CITY OF CORNELIUS  
COMMUNITY DEVELOPMENT DEPARTMENT

STAFF REPORT

**Kem Hoops**

**Type III Site Design Review (DR-129-22), Type III Conditional Use Permit (CUP-04-22) and Preliminary Land Partition (LP-03-22)**

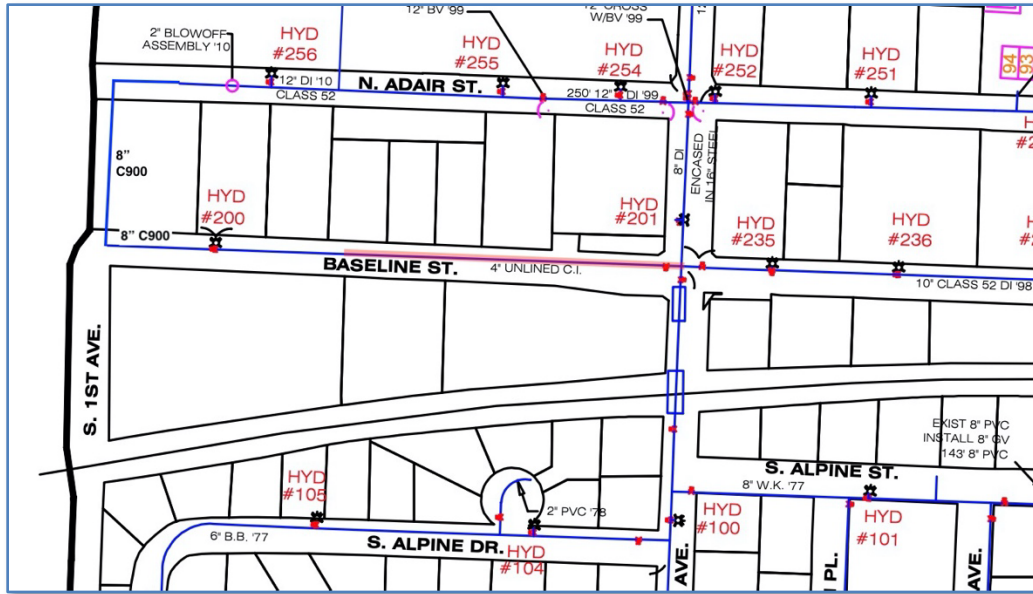
An 8-inch ductile iron water main exists on 4<sup>th</sup> Avenue adjacent to the site. This main meets current standards. A 4-inch unlined cast iron water main exists along the Baseline frontage that does not meet standards.

**The applicant is required to replace the water main along the Baseline frontage with an 8" C900 pipe.** The area where this replacement is necessary is shown in the map below with red shading.
